Product Change Notice

PCN No. 15-003

Part No. 3587	Existing Rev. c	Part Status:	<input checked="" type="checkbox"/> Active <input type="checkbox"/> Discontinued <input type="checkbox"/> Custom
Part Description: Fuse Holder			
Data Link: http://www.keyelco.com/product.cfm/product_id/310

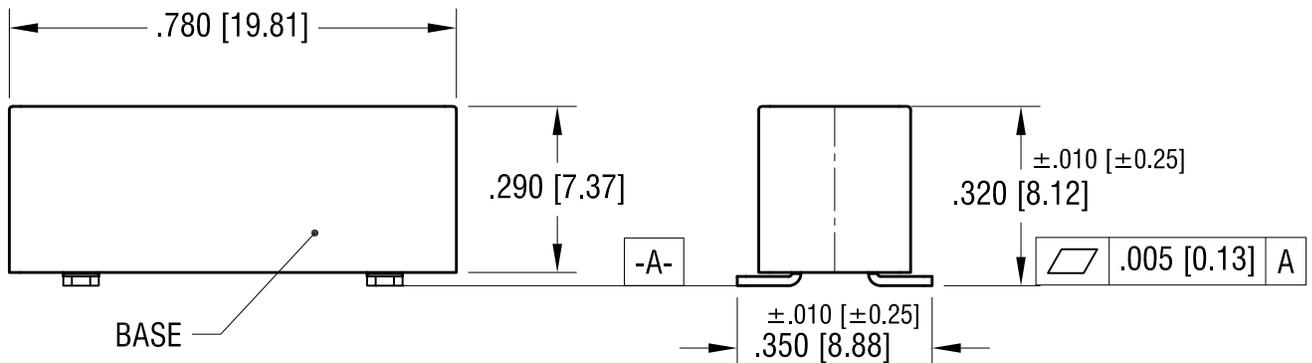
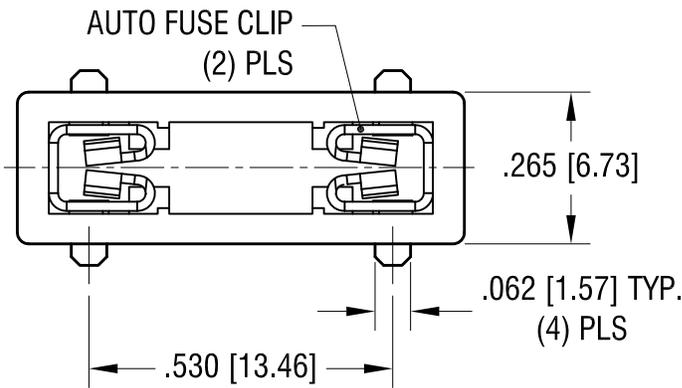
Description of Change: Overall height .320±.010 was .320±.005, dimension .350±.010 was .345±.005 MTG layout has been updated: .360 min. was .350 min	
Disposition of Stock: Use existing stock as is.	
Implementation Date: 3.13.15	Last Ship Date:
REACH Statement Link: http://www.keyelco.com/userAssets/file/reach.pdf	
RoHS Statement Link: http://www.keyelco.com/userAssets/file/RoHS_Statement.pdf	
DRC Mineral Conflict Declaration Link: http://www.keyelco.com/userAssets/file/Keystone-Electronics-Conflict-Materials-Statement.pdf	
Chief Engineer: Sign: 	Remarks Date: 3.13.15
Document Control: <input checked="" type="checkbox"/> Change Incorporated	New Rev.D Signed  Date: 3.13.15
